### **Comments on the air quality aspects of the EIS of the Beaches Link and Gore Hill Freeway Connection (SI-8862)**

# Review of the Beaches Link EIS

The review is based on the documents: Beaches Link and Gore Hill Freeway Connection Environmental Impact Statement (EIS) (December 2020) –Appendix H: *Beaches Link and Gore Hill Freeway Connection - Technical Working Paper: Air Quality*.

Figure 1: Emission deterioration factors for NO<sub>x</sub> (hot emissions) for diesel and gasoline light-duty vehicles by Euro standard applied in the new HBEFA 4.1<sup>1,2</sup>. The deterioration factors are derived from remote emission sensing measurements made in Europe<sup>3</sup>.

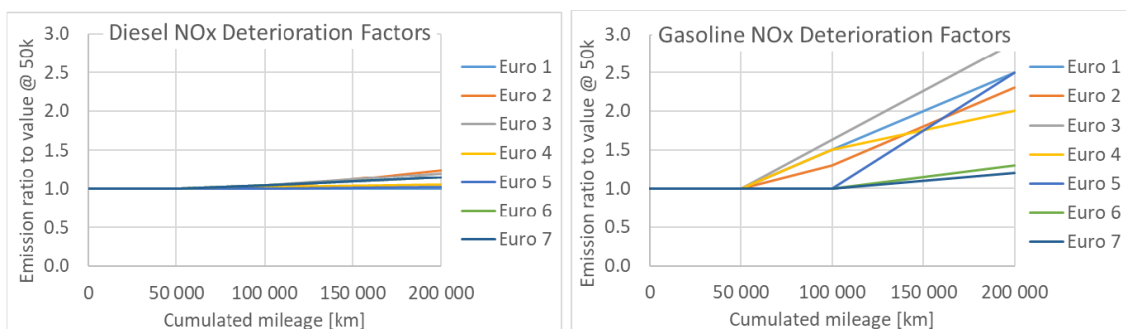
Since the PIARC-based approach applied to the Beaches Link tunnel does not consider emission deterioration as vehicles age beyond 150,000 km (see chapter 6.2.4.5 in the Ventilation Report –

Appendix H Part 2), modelled in-tunnel NO<sub>x</sub> emissions may be underestimated. However, it is not considered likely that the incorporation of deterioration factors in the emission modelling would affect the air concentrations of NO<sub>2</sub> in the tunnel that much, such that the adopted Air Quality Criteria for NO<sub>2</sub> of 0.5 ppm as an average along the tunnel would be exceeded in any of the scenarios. The rationale behind this assumption is that the NO<sub>x</sub> emissions in the tunnel by year 2027 will be dominated by diesel vehicles, since the NO<sub>x</sub> emissions from petrol vehicles on a g/km basis are much lower than for diesel vehicles up to and including Euro 5, and the deterioration of diesel NO<sub>x</sub> emissions is very slow (Figure 1). Also, since the EIS assumes that the Euro 6 emission standard will not be introduced in Australia until after 2027, this yields a conservative estimate of the in-tunnel NO<sub>x</sub> emissions (since it is considered likely that some Euro 6 vehicles will have penetrated the Australian fleet before 2027 anyway, regardless of the lack of Euro 6 legislation until then).
